## ADDENDUM #1

November 6, 2024

#### PROJECT: BATON ROUGE POLICE DEPARTMENT FIRST DISTRICT PRECINCT INTERIOR RENOVATIONS CITY PARISH PROJECT NO. 21-ASC-CP-1553

**1 Mechanical Plan**  
Scale: 1/8" = 1'-0"

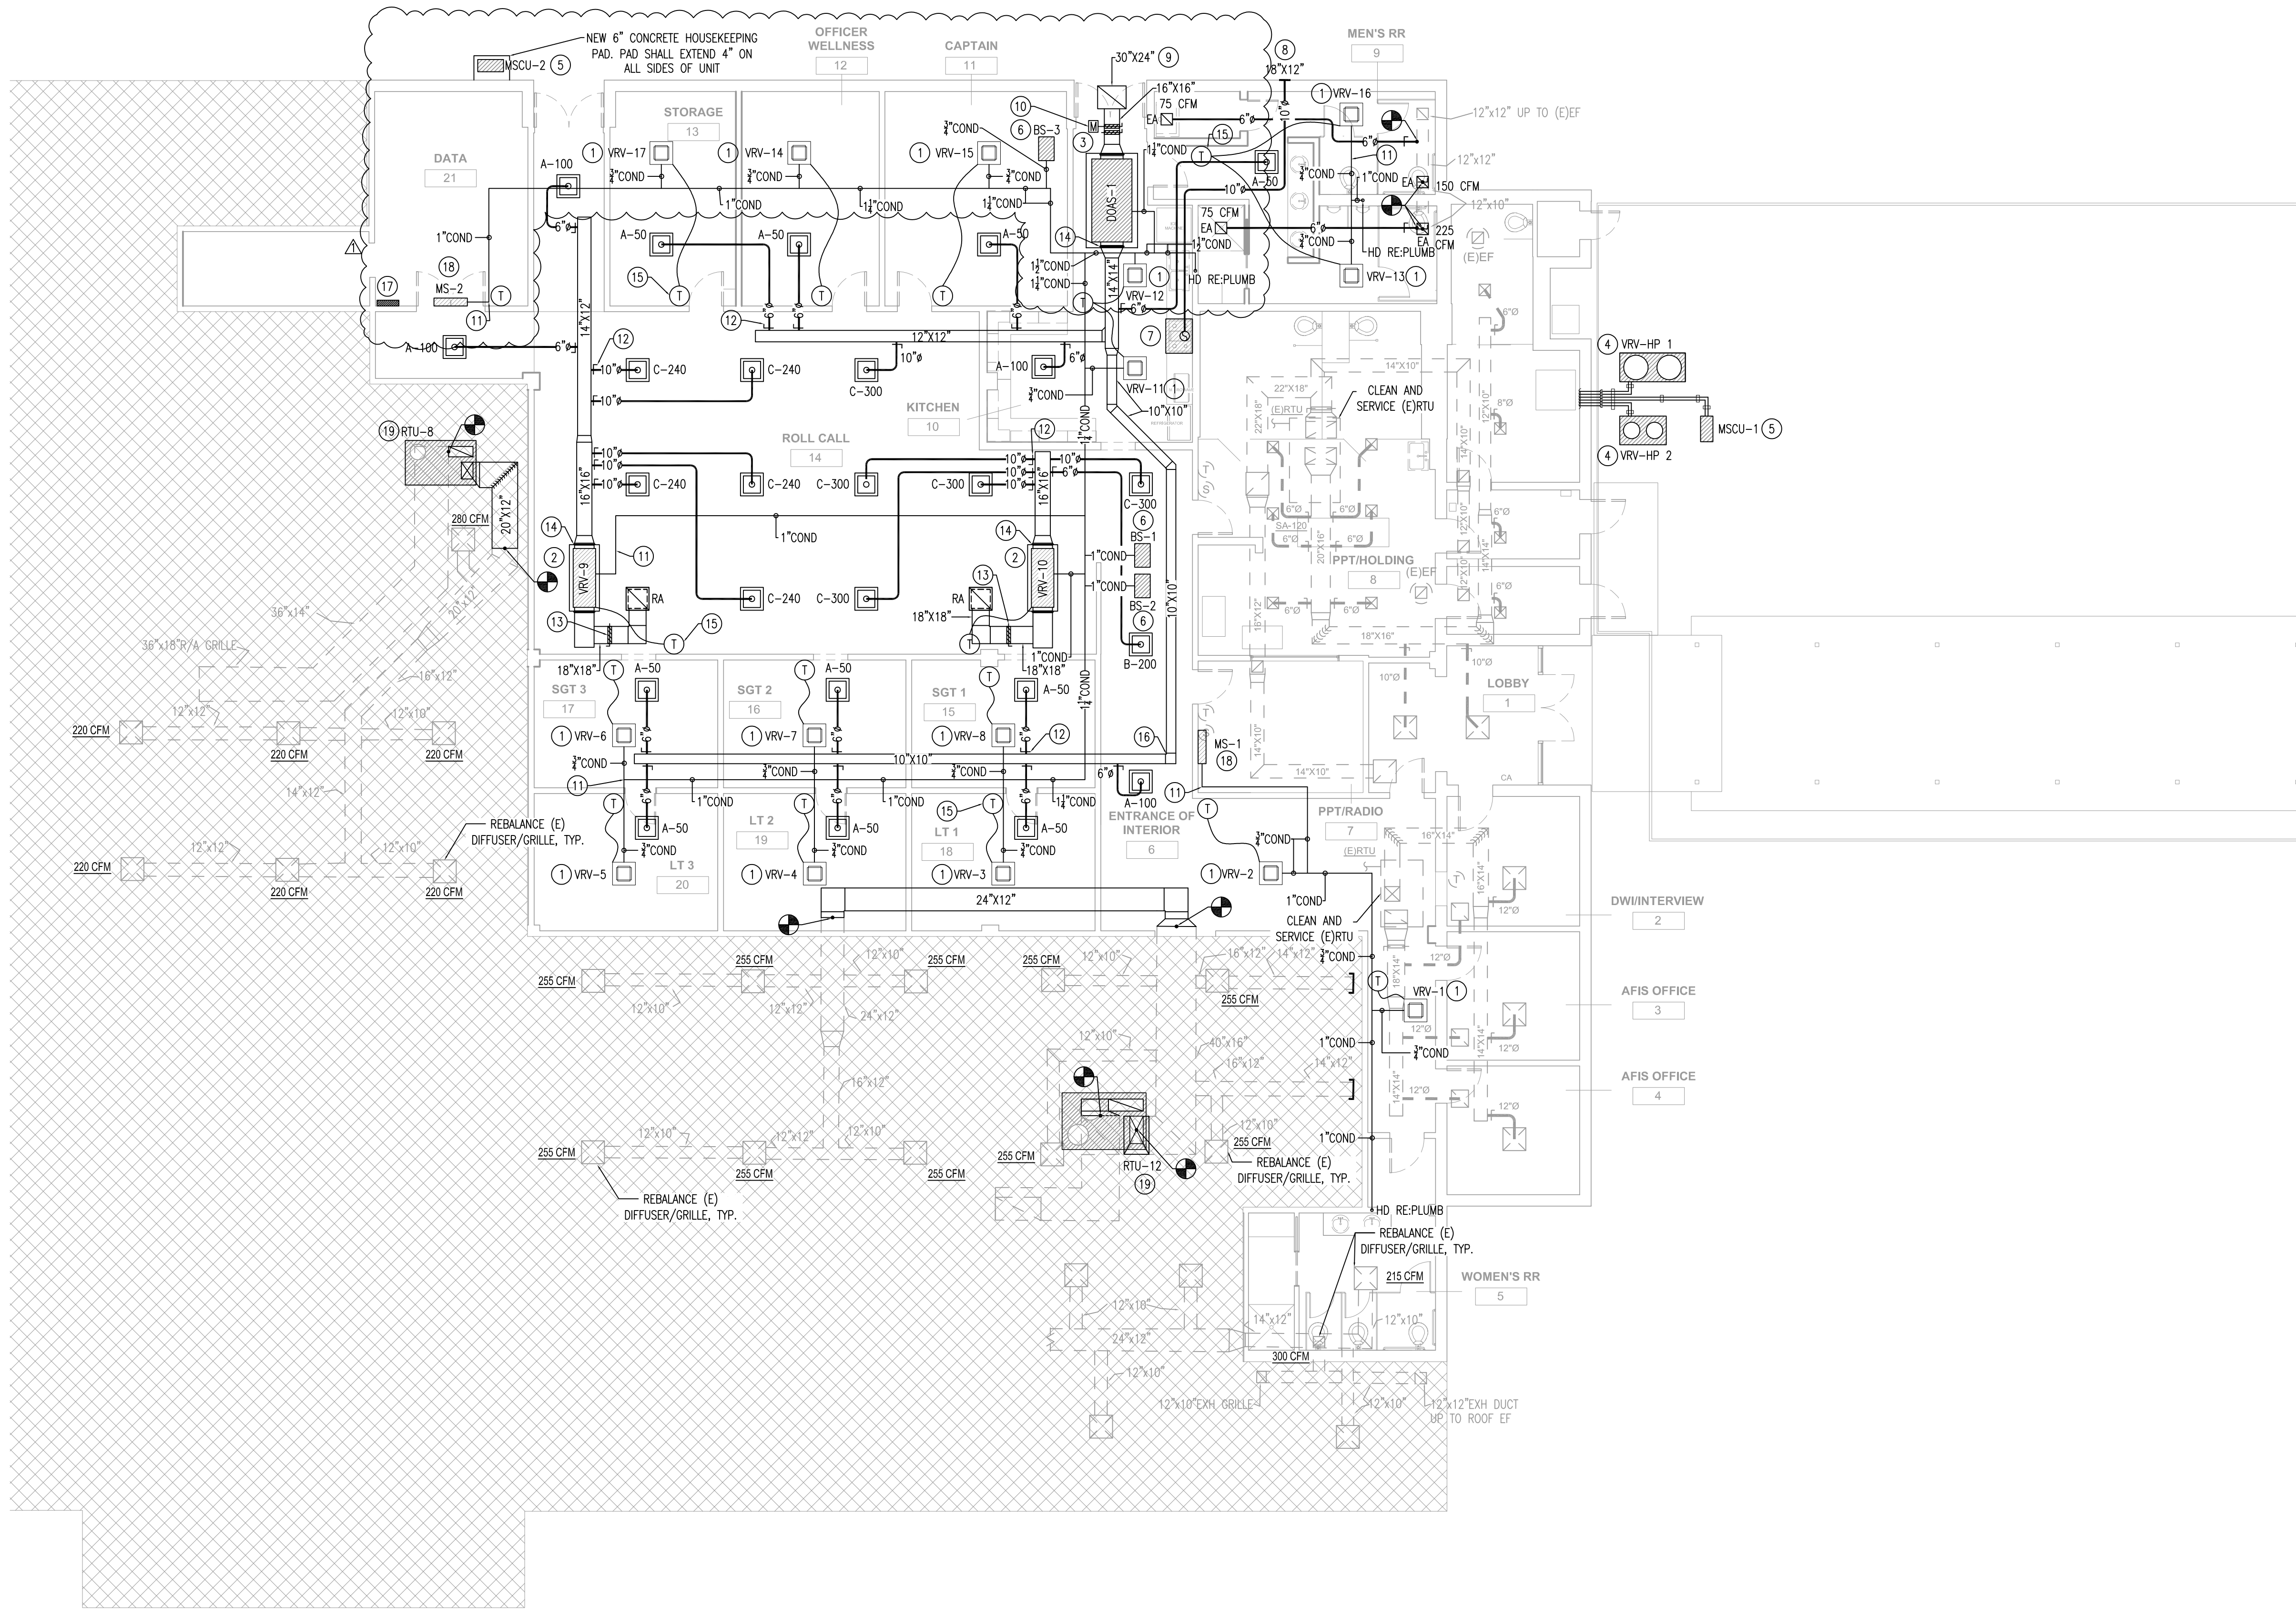
3. Sheet M1.1
  - a. Show locations of MS-2, MSCU-2. This shall be bid under Alternate #1.
  - b. Revise mechanical keynote #7.
  - c. Revise condensate piping sizes should Alternate #1 be accepted.
  - d. Remove existing supply/return air diffusers/grilles and caps ductwork in ceiling space of Data Room 21. This work shall be bid under Alternate #1. Existing shall remain should Alternate #1 not be accepted.
  - e. Relocate VRV control panel.
4. Sheet M2.0
  - a. Add MS-2, MSCU-2 to schedules. This shall be bid under Alternate #1.
  - b. Revise MS-1, MSCU-1 data on schedules.

**POWER PLAN**

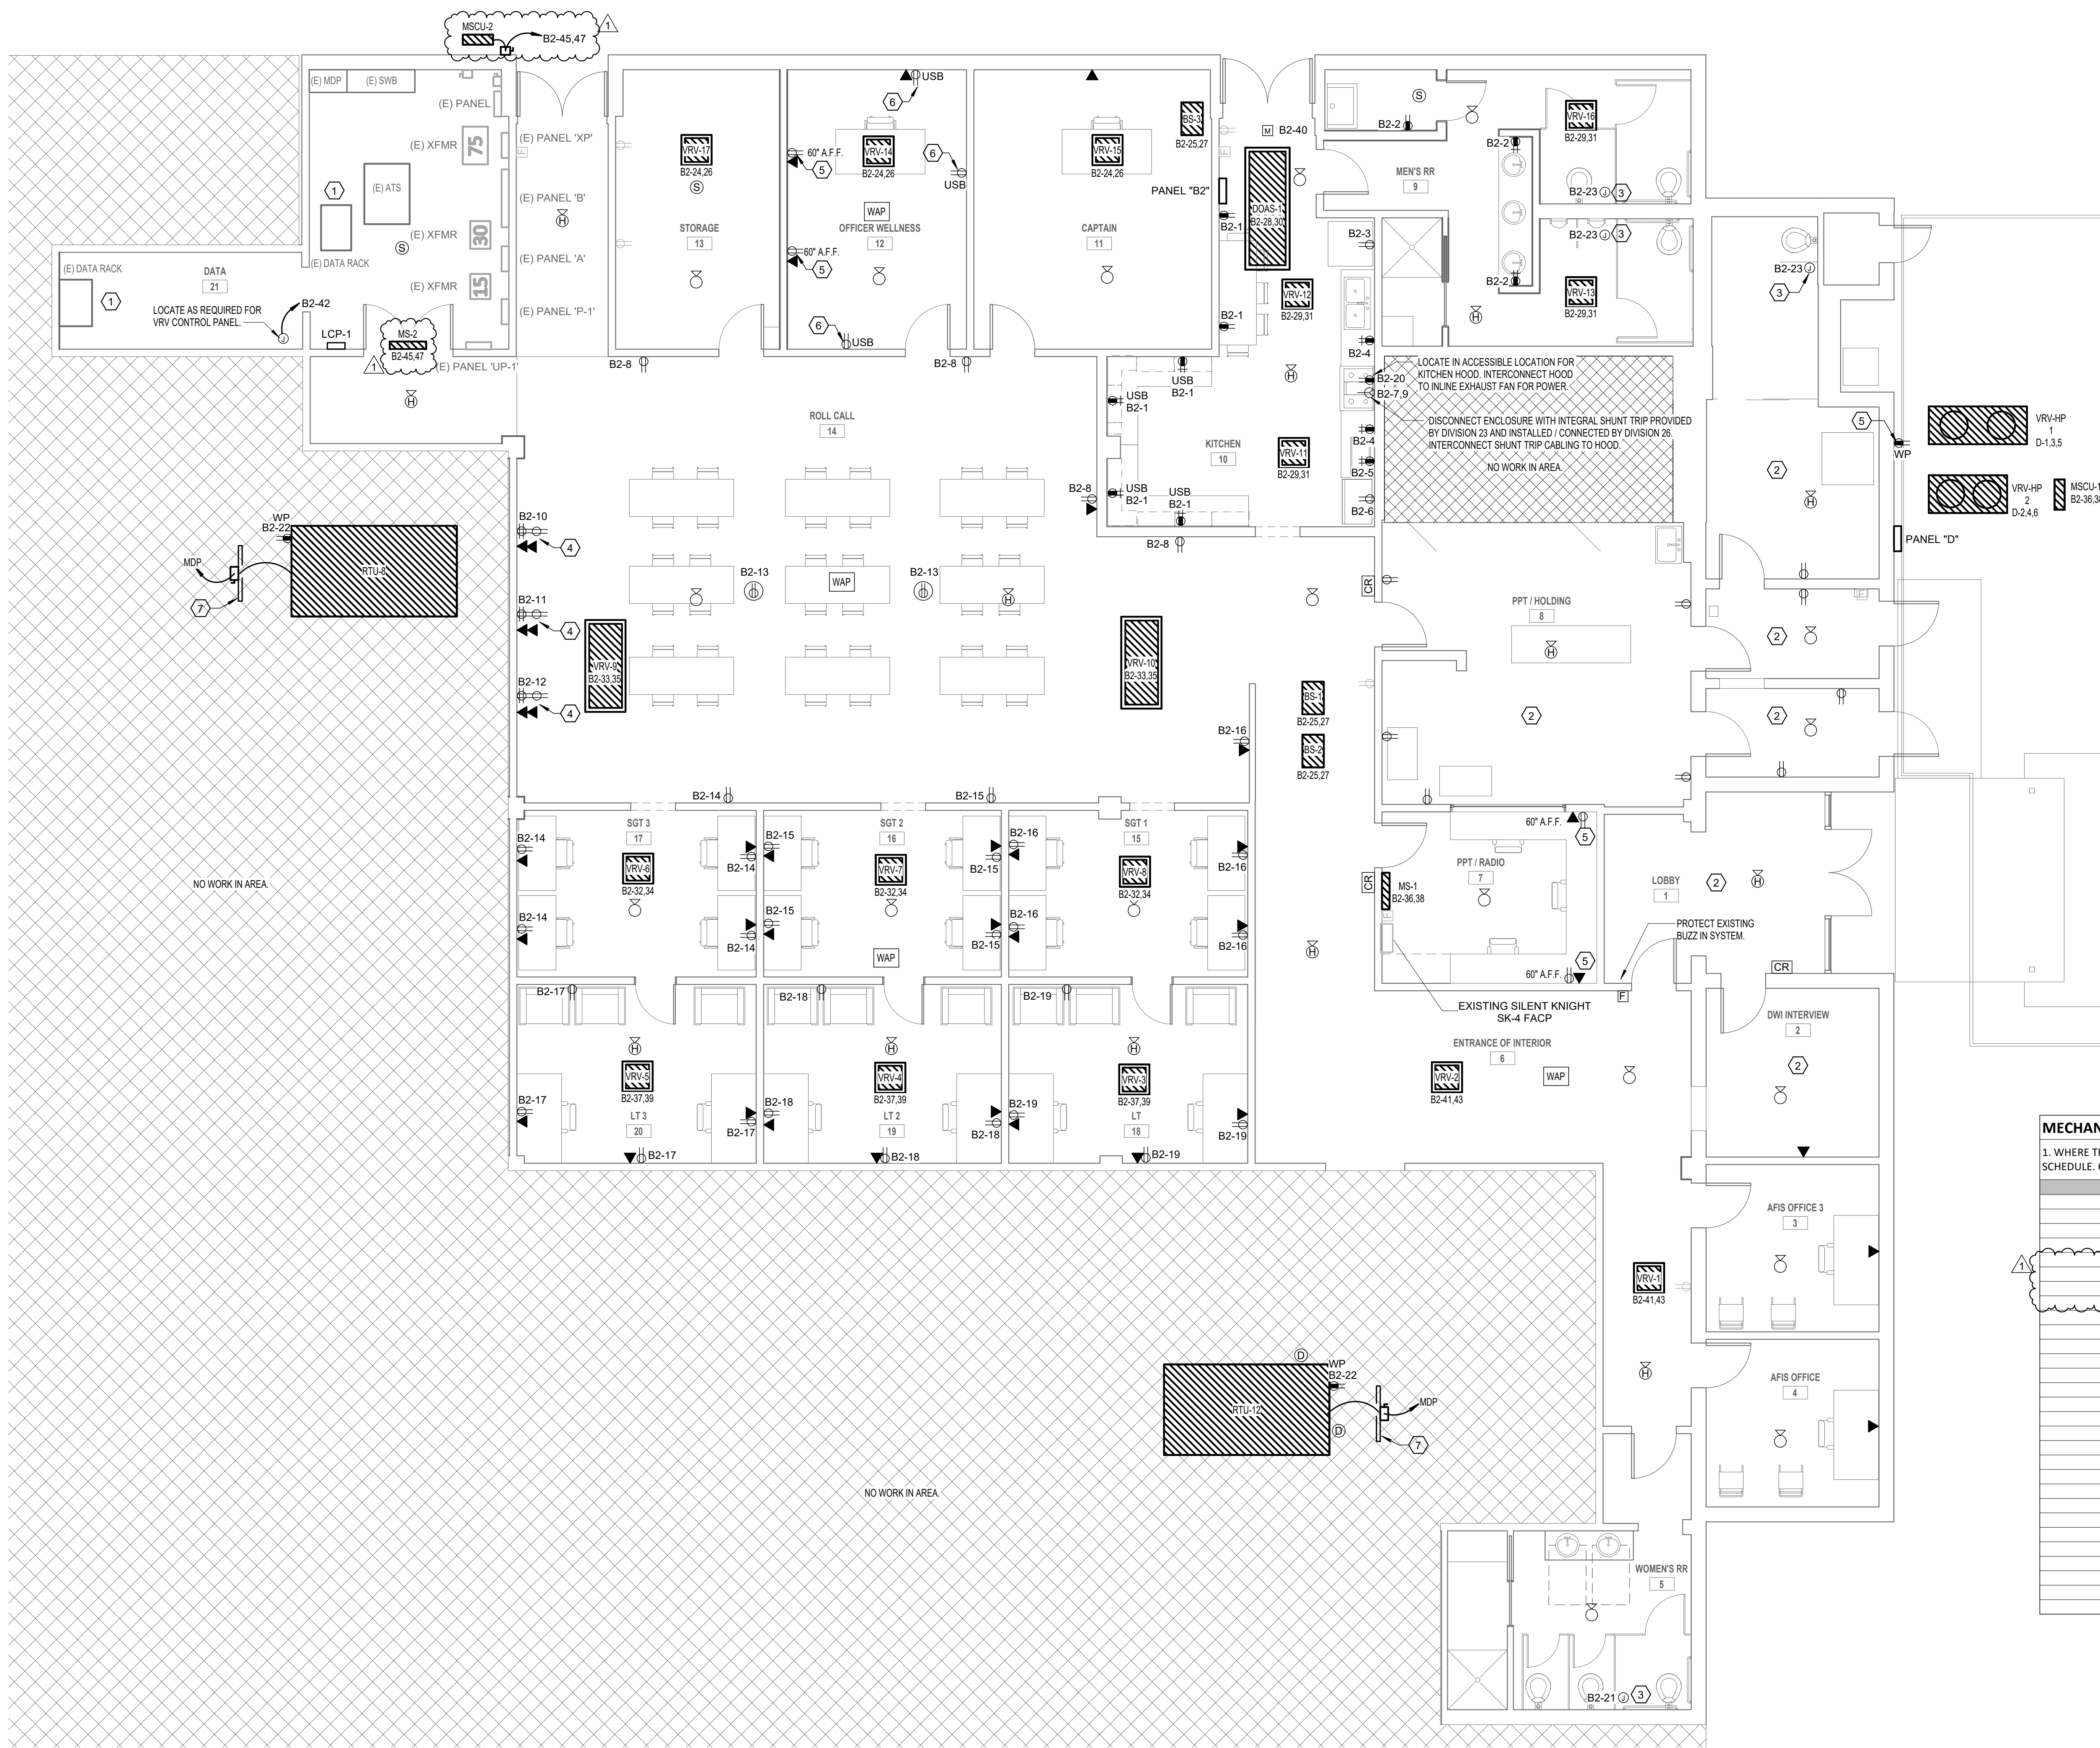
1. Sheet E4.0
  - a. Added MS-2 & MSCU-2 to power plan and connection schedule. This shall be bid under Alt. #1.
2. Sheet E5.0
  - a. Changed lighting fixture schedule selections.
3. Sheet E6.0
  - a. Added MS-2 & MSCU-2 to Panel Schedule “B2”. This shall be bid under Alt. #1
  - b. Changed name and breaker size of circuit 36, 38 on Panel Schedule “B2”.
